# UNITED STATES PATENT AND TRADEMARK OFFICE

**Office Action Summary**

10/532,332

***Detailed Action***

*Fig. 1*

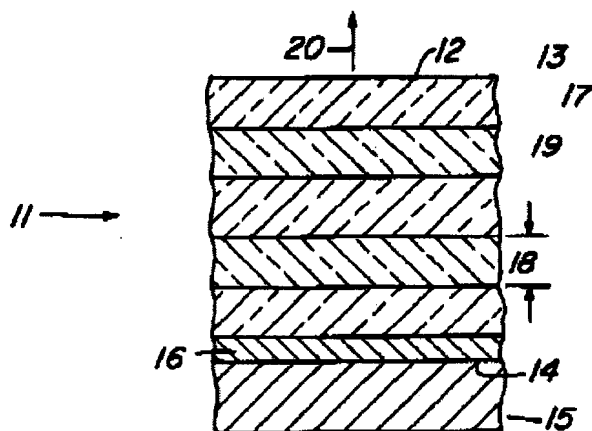
15. Bushman teaches an infrared light source (Note Figure 1 below) that includes energy source 15 that emits radiation through a multi-layered filter having an optical thickness selected to be one-quarter of the wavelength for the light 20 to be emitted. As the light passes through a boundary between alternating layers of different indexes of refraction it is partly refracted, and partly reflected, such that the transmitted light will be at one wavelength while the rest of the wavelengths will not transmit nor emit through the filter. Col. 3, line 37-67; and Col. 4, line 1-14.

16. Bushman modifies Bayly to provide a source that emits a laser-like monochromatic light at a selected wavelength in the infrared region determined by the optical thickness of the layers of the emitter member, while light at other wavelengths are not transmitted.

17. Therefore it would have been obvious to one of ordinary skill at the time the invention was made that Bayly would use the emitter of Bushman to provide a source that emits a laser like monochromatic narrow beam of light at a selected wavelength.
